To: T10 Technical Committee  
 From: Jay Neer (Jay.Neer@Molex.com)  
 Date: March 2, 2005  
 Subject: SAS 1-1 Compact Connectors (Internal and External)

This proposal has been prepared in the style of SAS 1-1 Rev 8, and identifies changes and additions to Rev 8.

Figure 61C — SAS external compact cable plug connector

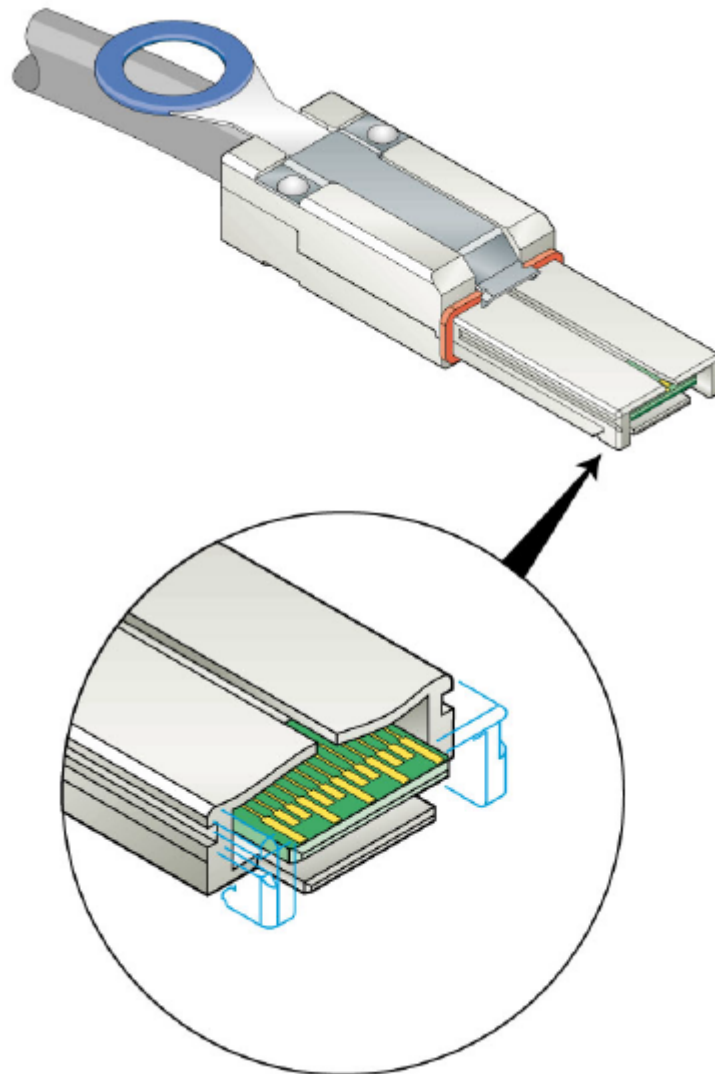
### 5.2.3.3.4 SAS external compact cable plug connector

The SAS external compact cable plug connector assembly is defined in SFF-8088 the four lane free plug connector with latch. SFF-8086 defines the circuit board (the circuit board is common to both internal and external connectors).

The SAS external compact cable plug connector shall not include keys and may include key slots. Key slots are not defined by this standard. The SAS external compact cable plug connector attaches to a SAS external compact receptacle connector, providing contact for up to four physical links.

**Figure 62C — SAS external compact receptacle connector**

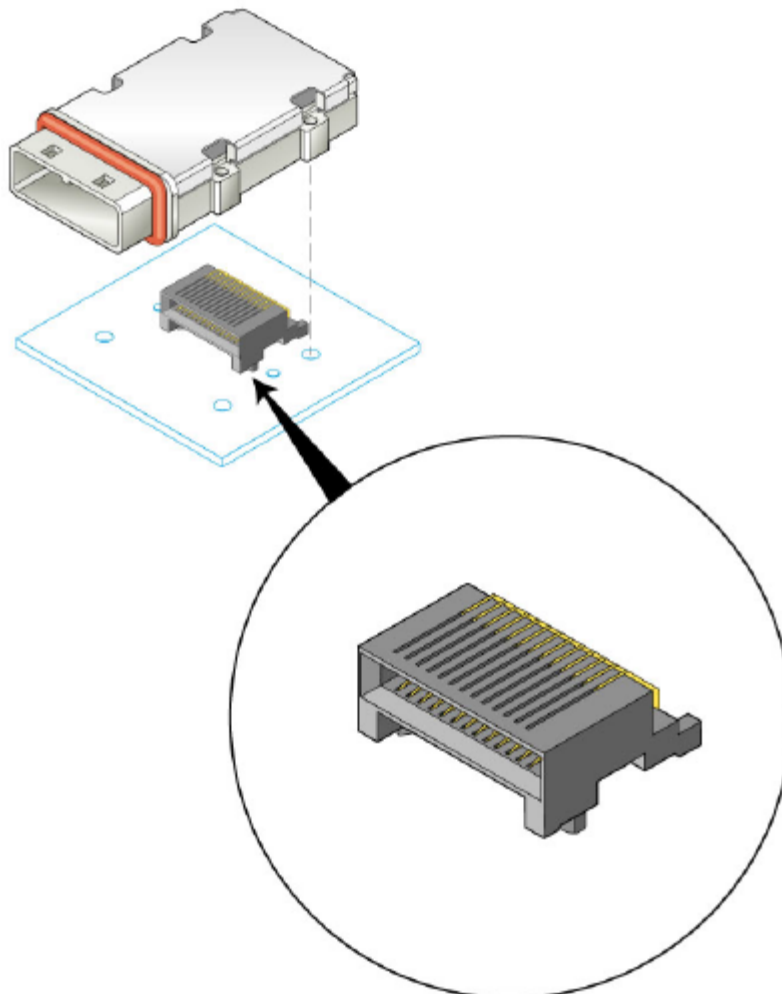
### 5.2.3.3.5 SAS external compact receptacle connector

SAS devices with external ports shall use the SAS external compact receptacle connector. The SAS external compact connector shell is defined in SFF-8088 as the four lane fixed receptacle connector with latch. SFF-8086 defines the receptacle mating interface and the board footprint (the receptacle body is common to both internal and external connectors).

The SAS external compact cable receptacle connector shall not include keys and may include key slots. Key slots are not defined by this standard. The SAS external compact receptacle connector attaches to a SAS external compact cable plug connector, providing contact for up to four physical links.

**Figure 63CW — SAS internal compact wide cable plug connector**

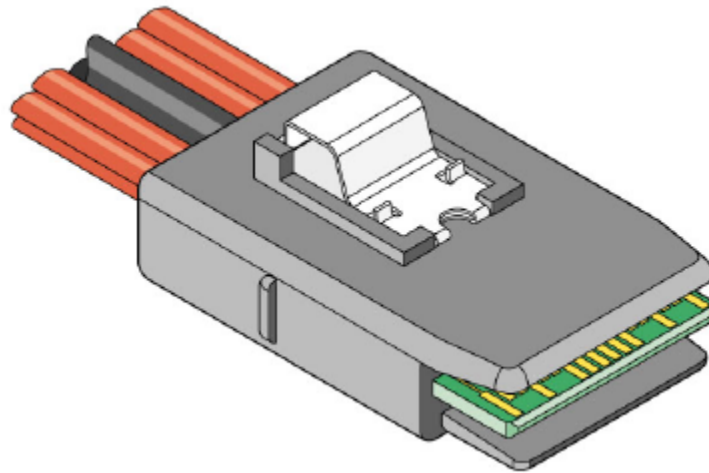
#### 5.2.3.4.4 SAS internal compact wide cable plug connector

The SAS internal compact wide cable plug connector assembly is defined in SFF-8087. SFF-8086 defines the circuit board (the circuit board is common to both internal and external connectors).

The SAS internal compact wide cable plug connector attaches to a SAS internal compact wide receptacle connector, providing contact for up to four physical links and six sideband signals.

**Figure 64CW — SAS internal compact wide receptacle connector**

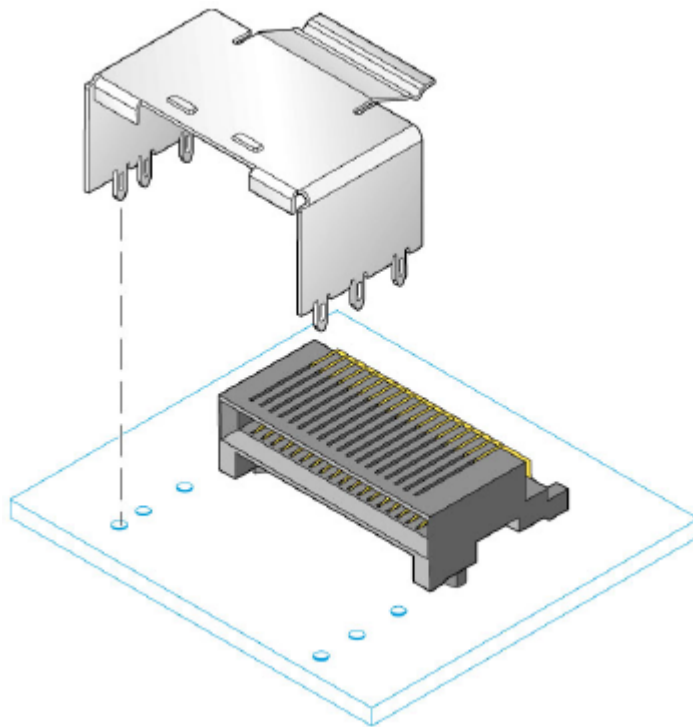
### 5.2.3.4.5 SAS internal compact wide receptacle connector

The SAS internal compact wide receptacle connector shell is defined in SFF-8087 and SFF-8086 defines the receptacle mating interface and the board footprint (the receptacle is common to both internal and external connectors).

The SAS internal compact wide cable plug connector attaches to a SAS internal compact wide receptacle connector, providing contact for up to four physical links and six sideband signals.
